Addendum No. 1

Wallula Bridge – CRP 22-03

BID PROPOSAL **WALLULA AVENUE MP 0.00 TO MP 0.20 WALLULA BRIDGE**

CRP 22-03

SHEET
36
36 OF 47

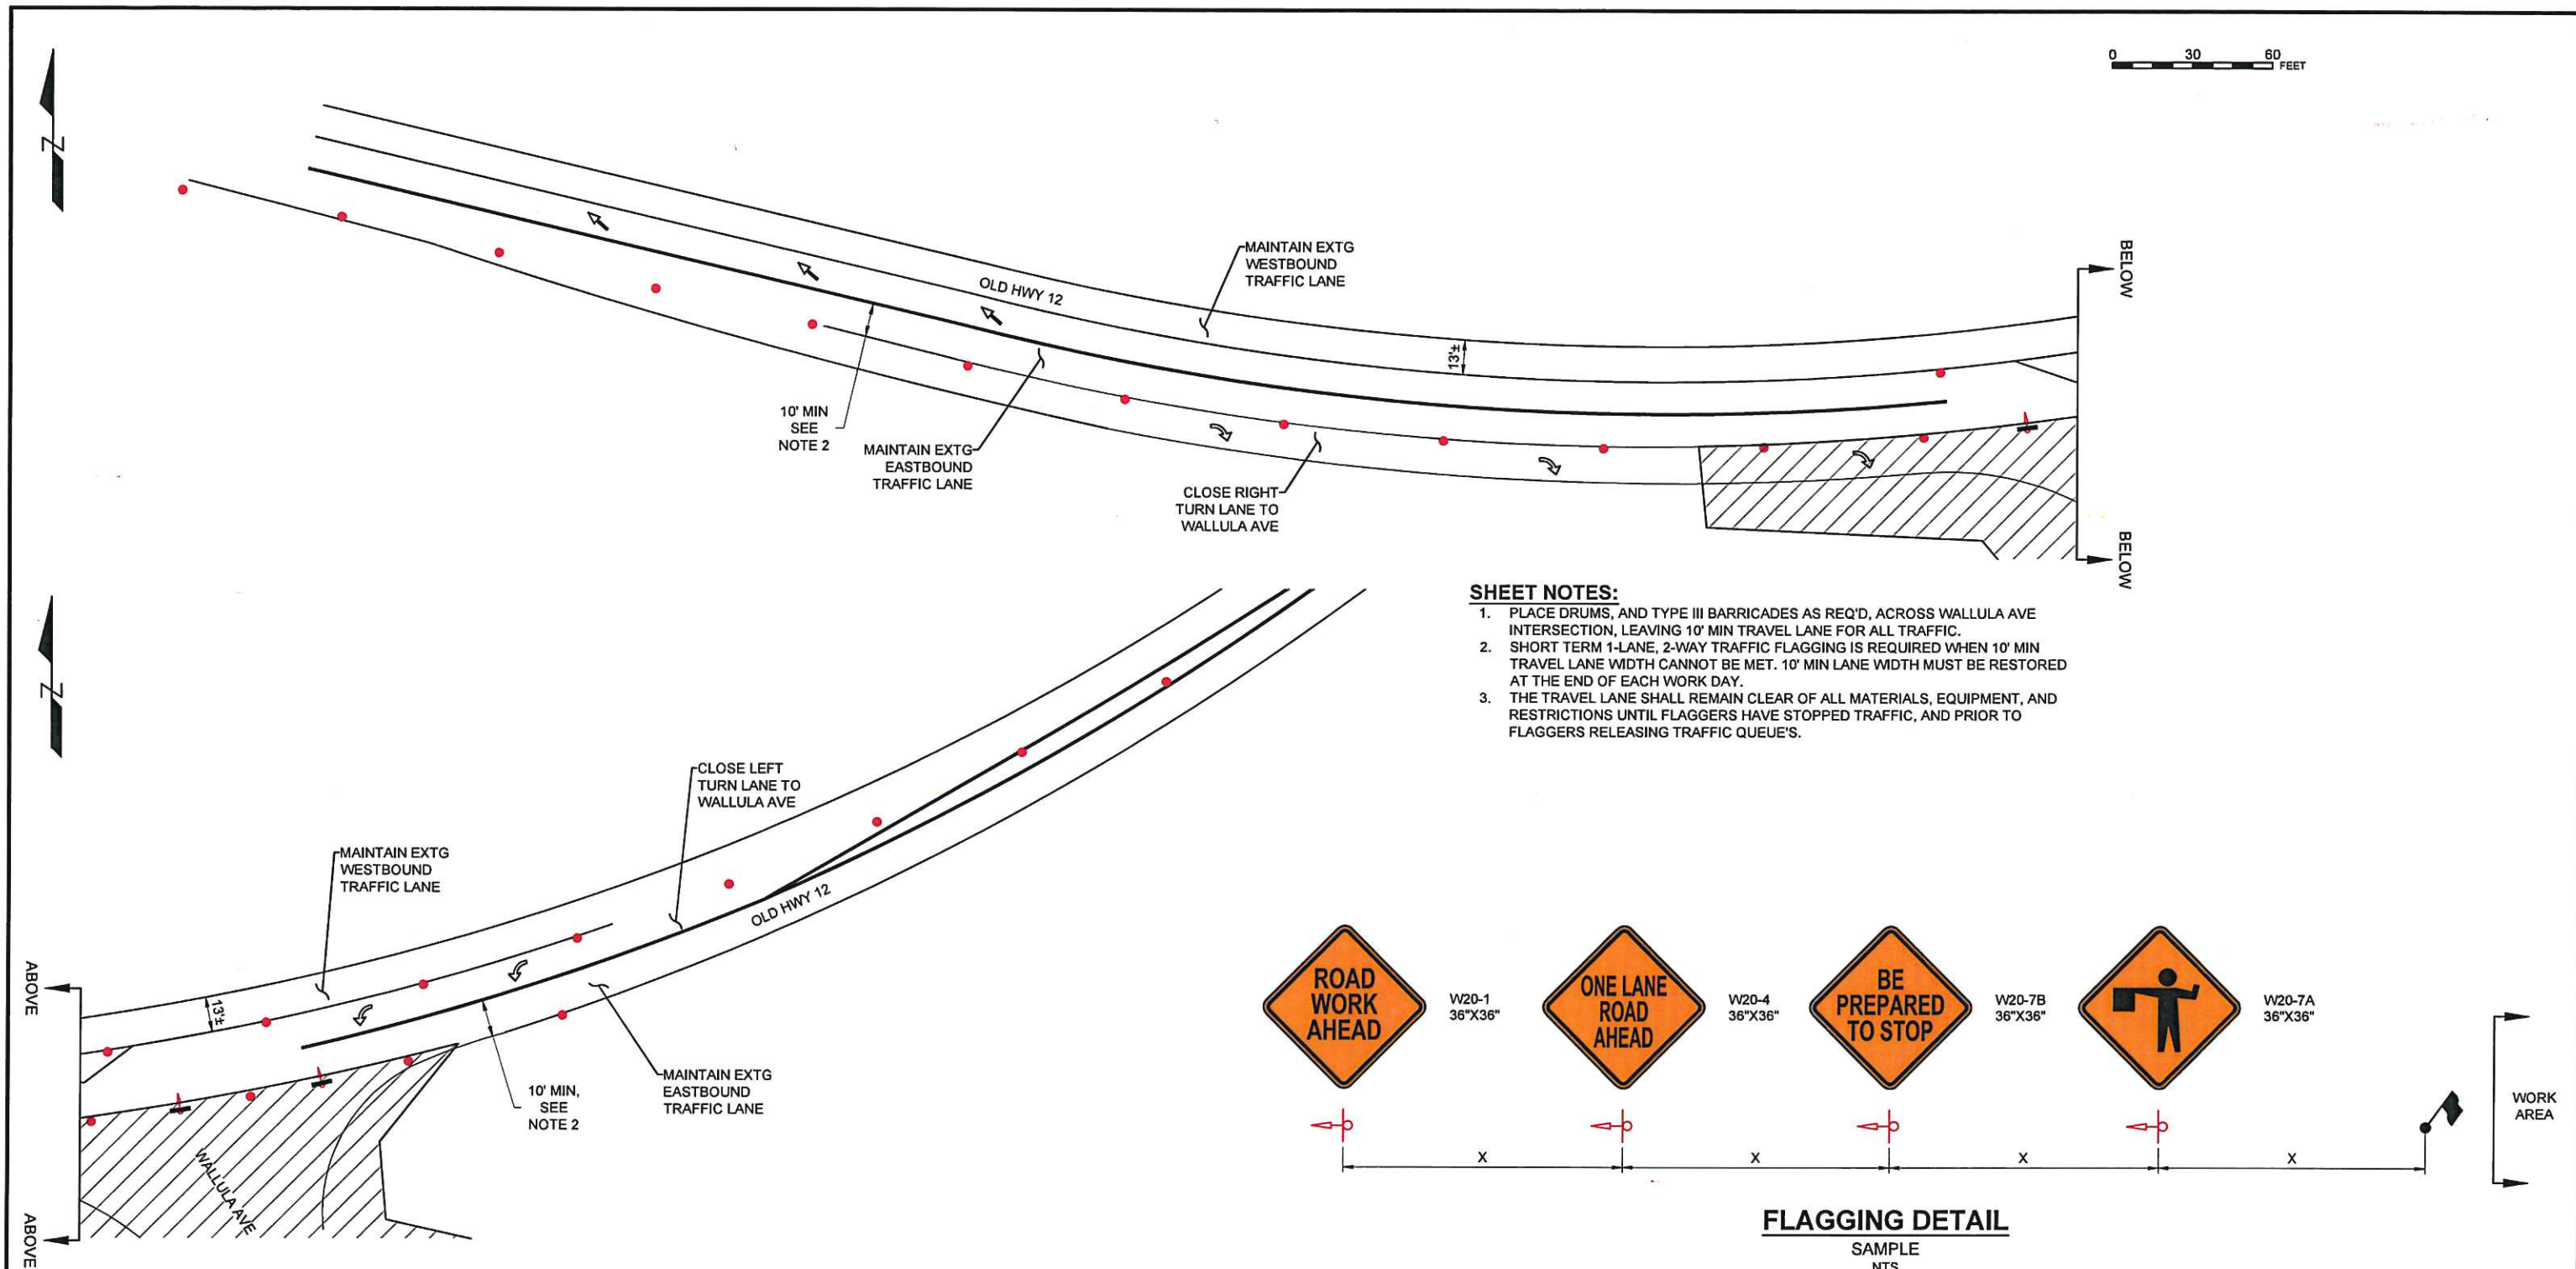
Sheets 36 & 37 of the Plans (Traffic Control Plan) are replaced with the following:
(Note: Due to revision of the Traffic Control Plan)
